# PARK CITY MUNICIPAL CORPORATION PLANNING COMMISSION

July 27, 2016

# Planning Commission Staff Report

**Subject:** 100 Daly Avenue  
**Project #:** PL-16-03185  
**Author:** Ashley Scarff, Planning Technician  
**Date:** July 27, 2016  
**Type of Item:** Administrative – Steep Slope Conditional Use Permit

FRONT ELEVATION  
SCALE: 1/4" = 1'-0"

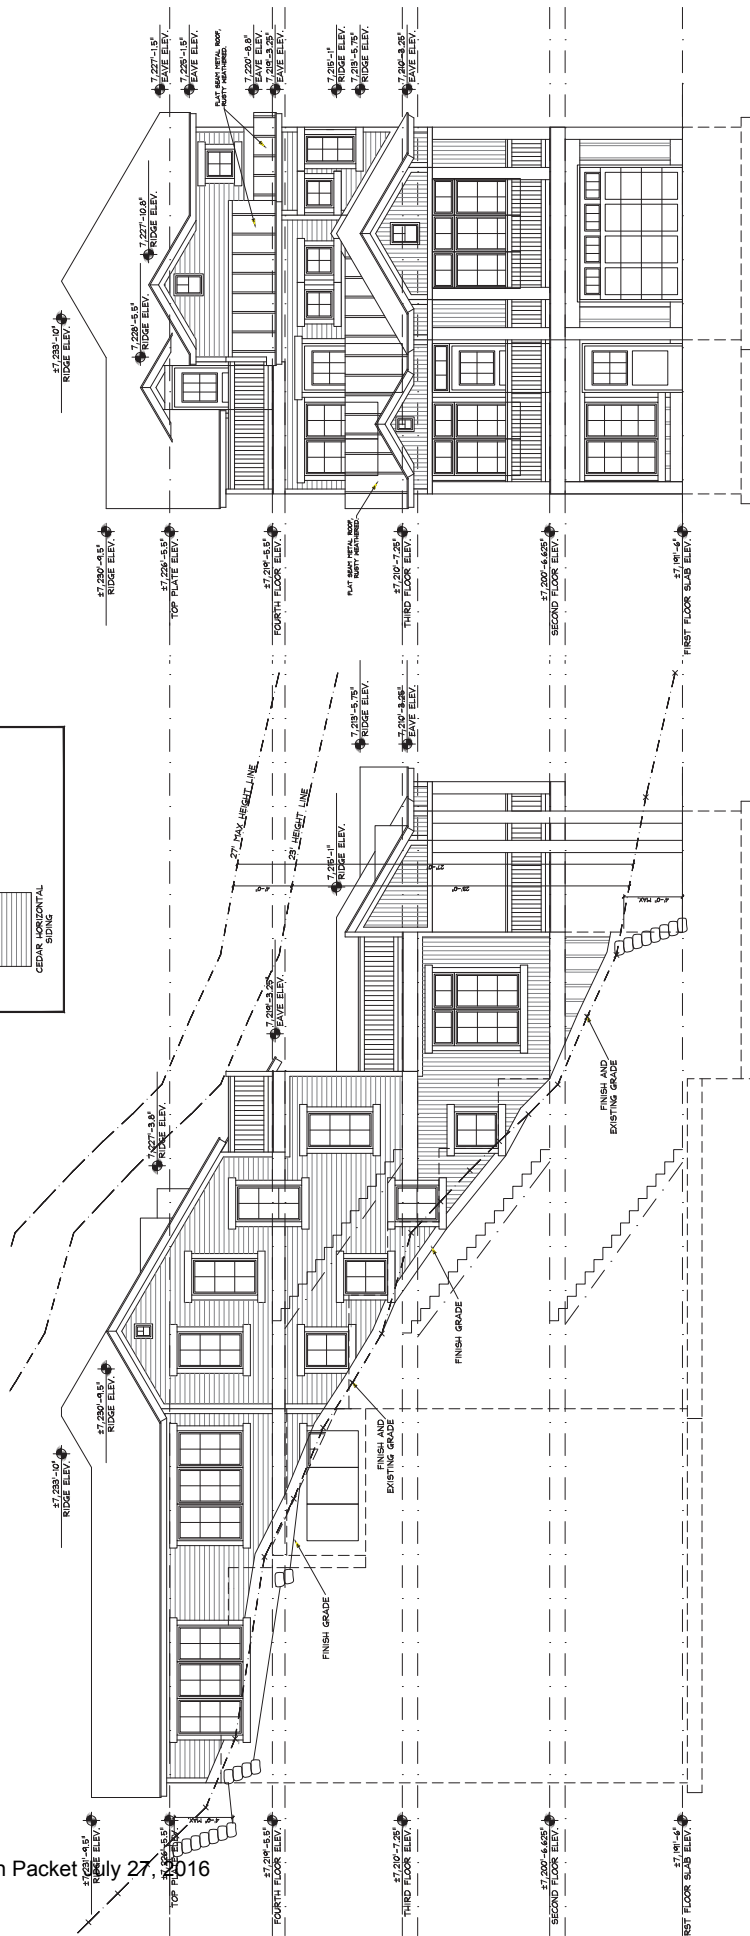
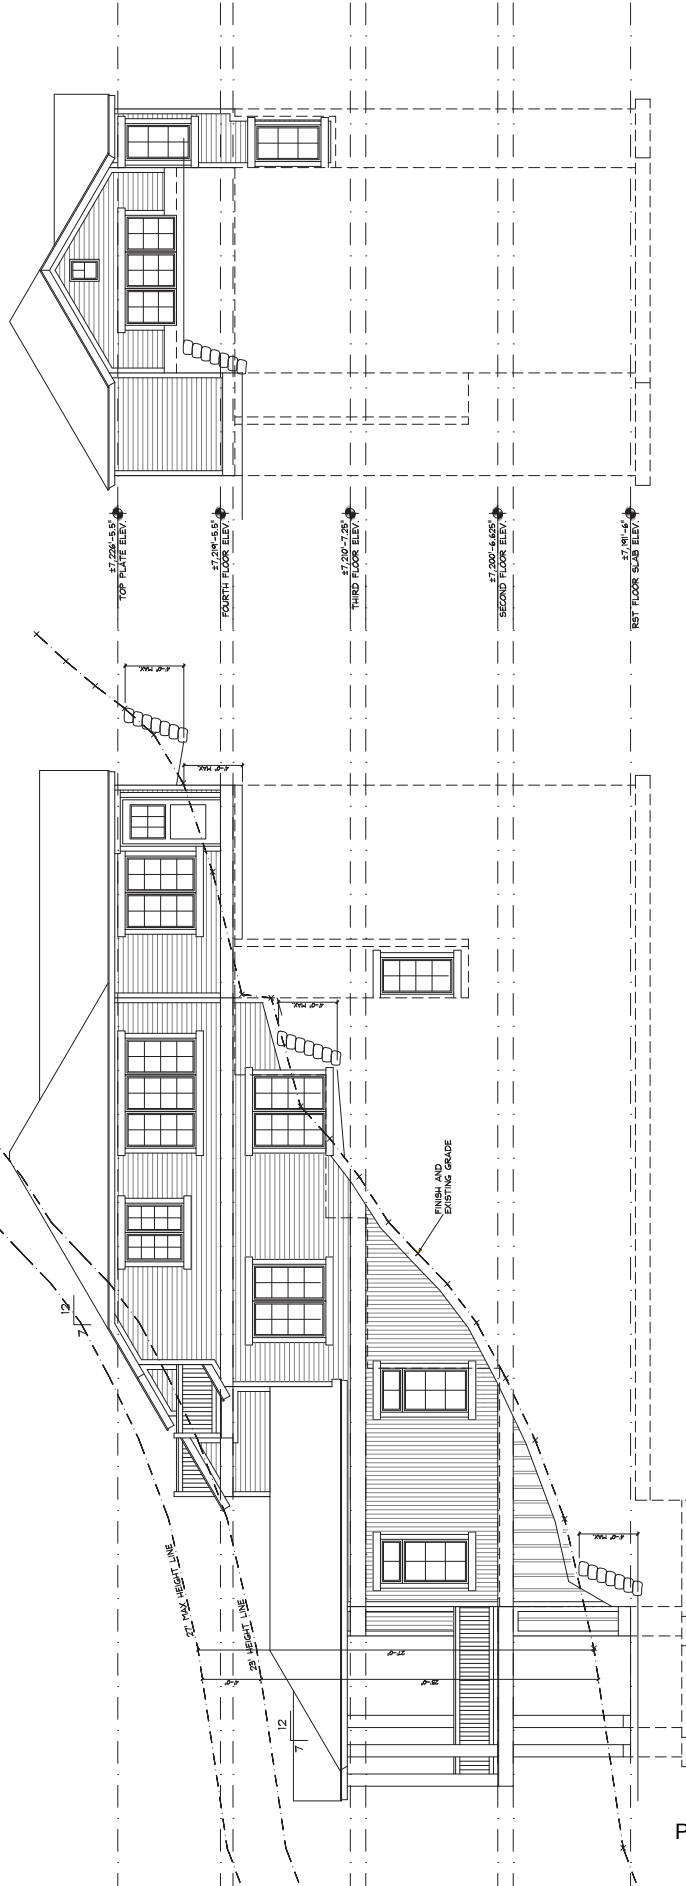
Height (continued)	A Structure shall have a maximum height of 35 feet measured from the lowest finish floor plane to the point of the highest wall top plate that supports the ceiling joists or roof rafters.	Approximately 34.9 feet, <u>complies.</u>
Final grade	Final grade must be within four (4) vertical feet of existing grade around the periphery of the structure.	Maximum difference is 4 feet on the north, south, and west elevations, <u>complies.</u>
Vertical articulation	A ten foot (10') minimum horizontal step in the downhill façade is required unless the First Story is located completely under the finish Grade on all sides of the Structure. The horizontal step shall take place at a maximum height of twenty three feet (23') from where Building Footprint meets the lowest point of existing Grade. Architectural features, that provide articulation to the upper story façade setback may encroach into the minimum 10 ft. setback but shall be limited to no more than 25% of the width of the building encroaching no more than 4 ft. into the setback.	Current plans show an approximate 9 ½ foot (9½') horizontal step in the downhill façade. The LMC requires a 10 foot step. Staff has added a condition of approval to this steep slope CUP to ensure compliance with the vertical articulation requirement of the LMC, <u>conditioned to comply.</u>

*As outlined above, the structure as shown in the current plans has an approximate 9 ½ foot (9.5') vertical step in the downhill façade, which is 6 inches (6") short of the LMC requirement of a 10 foot (10') vertical step in the downhill façade. Staff has conditioned the approval of this steep slope CUP to ensure that revised plans are in compliance with the vertical articulation requirement of the LMC.*
